CHIQUITA CANYON

Ref.: Respuesta de Chiquita Canyon, LLC al Aviso de la Determinación de Incumplimiento Propuesta con Determinación de Peligro Inminente y Sustancial y Orden del 26 de diciembre de 2025 en el Asunto del Vertedero de Chiquita Canyon, Expediente No. HSA-FY24/25-082

Respuesta de Chiquita Canyon, LLC al Aviso de la Determinación de Incumplimiento Propuesta

Figura 1– Diseño de la Barrera Solicitada por el DTSC²⁸

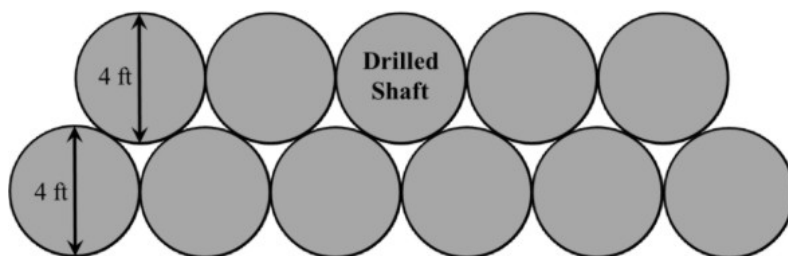
Chiquita también indicó inequívocamente en su respuesta del 9 de abril de 2025 que no construiría una barrera consistente con el diseño del DTSC y presentó suficientes defensas de causas del por qué.²⁵ El Código de Salud y Seguridad indica que solo las partes que no se atienen a una orden "sin causa suficiente" están sujetas a penalidades.²⁶ El diseño solicitado por el DTSC, que se muestra a continuación en la Figura 1, requeriría "excavar un eje vertical utilizando un equipo de perforación por barrena de tres o cuatro pies", llenando el eje "con mezcla de tierra-bentonita o de tierra-cemento" e instalando ejes "tangentes" y filas de ejes verticales.²⁷ Como se explicó previamente al DTSC y se reitera a continuación, la barrera solicitada por el DTSC no solo no tiene fundamentos científicos, sino que además sería físicamente imposible de construir. En resumen, la barrera solicitada por el DTSC

fue y es arbitraria, caprichosa, no está sustentada por evidencia sustancial y no cumple de ninguna manera con la ley y sería dañina para la comunidad.
